MEETING MINUTES, OPERABLE UNIT 5 CORRECTIVE MEASURES STUDY/FEASIBILITY STUDY
(CMS/FS)

- 1 The meeting was held on November 17, 1994 to present the upcoming strategy for the CMS/FS for Operable Unit 5 (OU 5) Copies of the presentation materials are attached

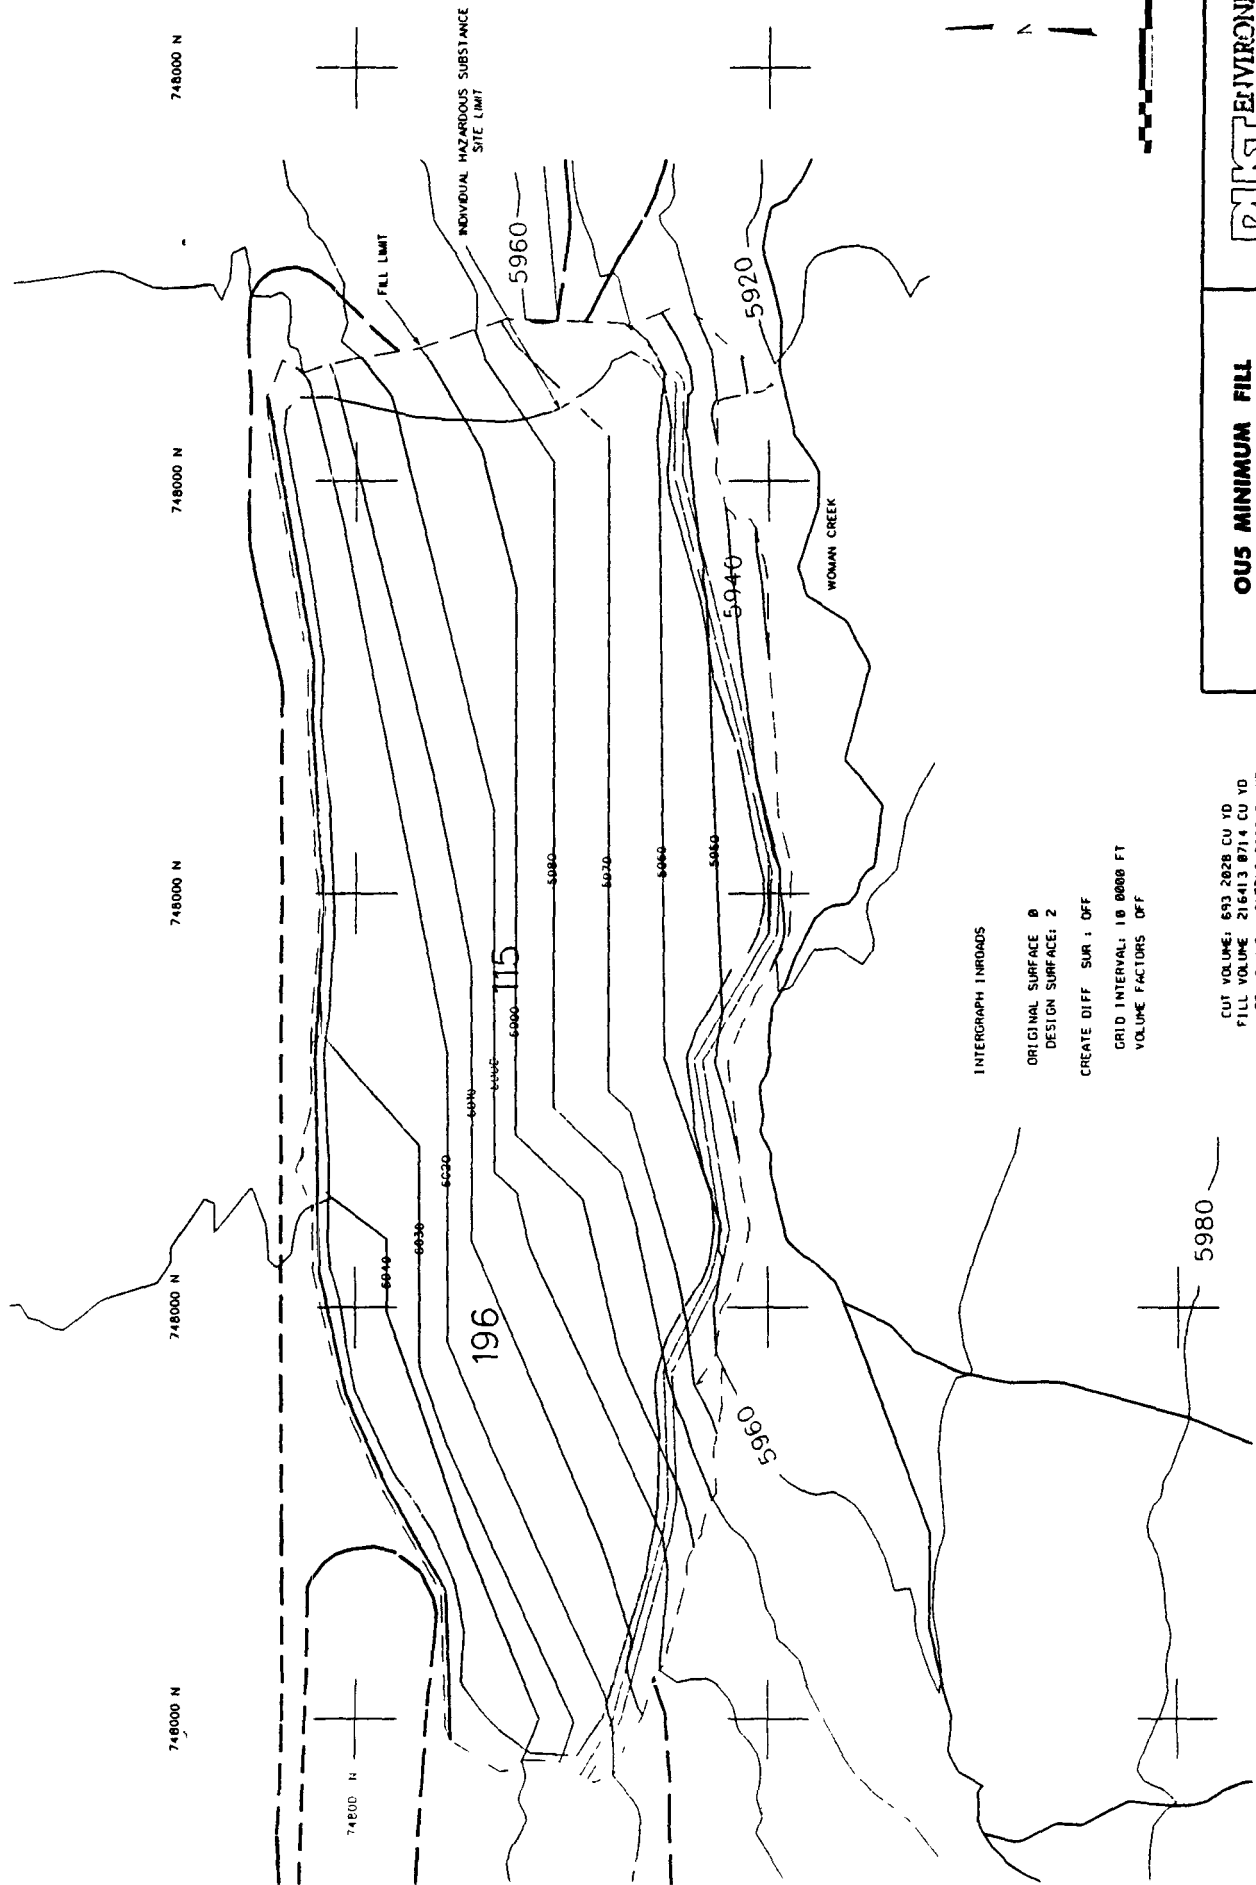
- J Schieffelin, CDPHE, asked if the areal size was still being determined? *Yes, a "worst case" grading plan has been drafted (see attachments).*
 - J Schieffelin, CDPHE, asked if the portion of the South Interceptor Ditch (SID) within the landfill would be sacrificed? *Yes, but only that part which runs through the landfill. The EG&G Surface Water Division has been updated to ensure that sitewide surface water drainage is considered.*
